Access Compliance Report Public Rights-of-Way (Curb Ramps)

Intersection ID: 51750 Main Street: GOLF_LINKS_DR_N Cross Street: ALLISON_WOODS_DR Location: SW ADA ID: 02CEABF6EF01 Ramp Type: Perp Initial Pass/Fail: Fail **Overall Compliance: No** Severity Score: 13.75

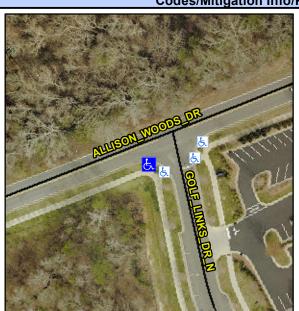
Possible Solutions:	Con
	N/A
Remove & Replace Entire Ramp.	
	Yes
	N/A
	N/A
	N/A
	N/A
Surveyor Notes:	N/A
N/A	N/A
	N/A
	N/A
	N/A
PROW/ADA:	N/A
Not Found, R304.2.2	N/A
	N/A
	N/A
	N/A

Field Measurements/Component Compliance							
Compliance Description		Data	Comp	liance Description	Data		
N/A	Ramp Length (in)	78.0	No	Ramp Slope (%)	10.1		
Yes	Ramp Width (in)	48.0	Yes	Ramp XSlope (%)	3.5		
N/A	Flare Type LT	N/A	N/A	Flare Type RT	N/A		
N/A	Flare Slope LT (%)	N/A	N/A	Flare Slope RT (%)	N/A		
N/A	Flare Traversable LT?	N/A	N/A	Flare Traversable RT?	N/A		
N/A	Landing Length (in)	N/A	N/A	DWS Provided?	N/A		
N/A	Landing Width (in)	N/A	N/A	DWS Contrast?	N/A		
N/A	Landing Slope (%)	N/A	N/A	DWS Length (in)	N/A		
N/A	Landing X Slope (%)	N/A	N/A	DWS Full Width?	N/A		
N/A	Landing Curb? (Y/N)	N/A	N/A	DWS Offset (in)	N/A		
N/A	Shared Landing?	N/A					
N/A	Gutter Ponding?	N/A	N/A	Gutter Slope (%)	N/A		
N/A	Gutter Lip Ht (in)	N/A	N/A	Gutter X Slope (%)	N/A		
N/A	Painted X Walk1?	No	N/A	Painted X Walk2?	N/A		
	X Walk 1 Direction	To N		X Walk 2 Direction	N/A		
N/A	X Walk 1 Width (in)	N/A	N/A	X Walk 2 Width (in)	N/A
